## DEVELOPMENT REVIEW COMMITTEE (DRC) COMMENT REPORT

**PROJECT NAME:** Gallery at Flagler Village

**CASE NUMBER:** UDP-S23006

**REQUEST:** Site Plan Level II Review: Mixed-Use Development with  
263 Multifamily  
Residential Units Inclusive of 150 Affordable Residential  
Units and 2,500  
Square-Feet of Commercial Use in Downtown  
Regional Activity  
Center

**Civil Sheet C-2 date on plans 08-24-2023.**

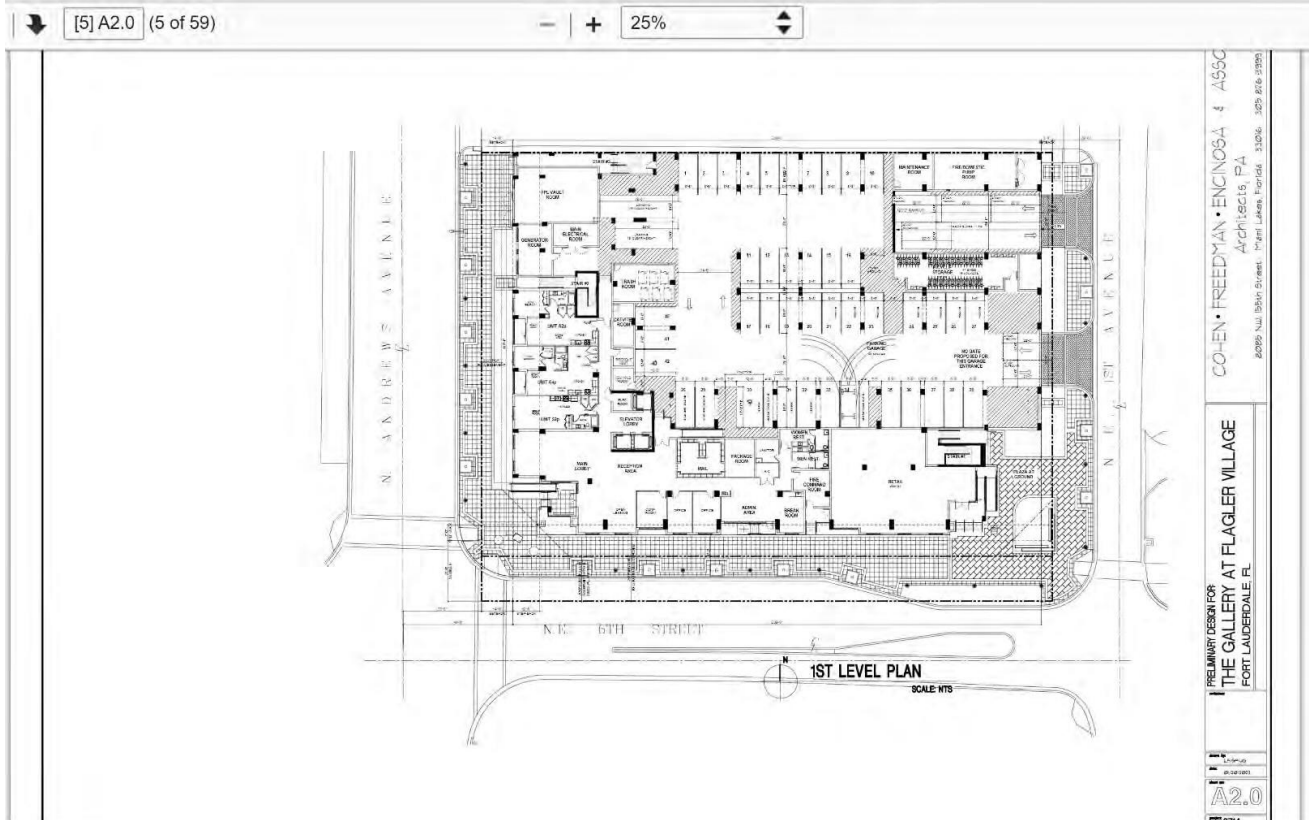
**Comment 2 (Civil Sheet C-2 date on plans 08-24-2023 shows elevation of finish floors below BFE + 1) (See attached Sheet C-2 date on plans 08-24-2023)**

(Floodproofing is allowed for mixed use buildings only. See link below on floodproofing.

Proper flood venting with flood vents and flood resistant materials required below base flood elevation in an flood zone (**Base flood elevation is 6' NAVD 88 + 1 foot freeboard +7 feet NAVD 88** ), please show and label rooms use and if storage room label as such and provide flood vents in all enclosed rooms below BFE 7' NAVD 88. (Flood vents are required at 1 square inch for every square foot of enclosed area) on (opposing walls). Example if you use a type of smart vent/flood vent that is certified to cover a 200 square foot area than if you place each vent on opposite walls so that flood waters flow in and out that would cover a 400 square foot area this is only given as an example)

- **Response: Acknowledged, elevations are now shown and flood vents noted to be added as required. See SP-1 and A2.0.**

- **Response: All pedestrian areas in the ROW are to be ADA compliant including covers, lids, etc. A note has been added on sheet C-2. (City Note #2)**
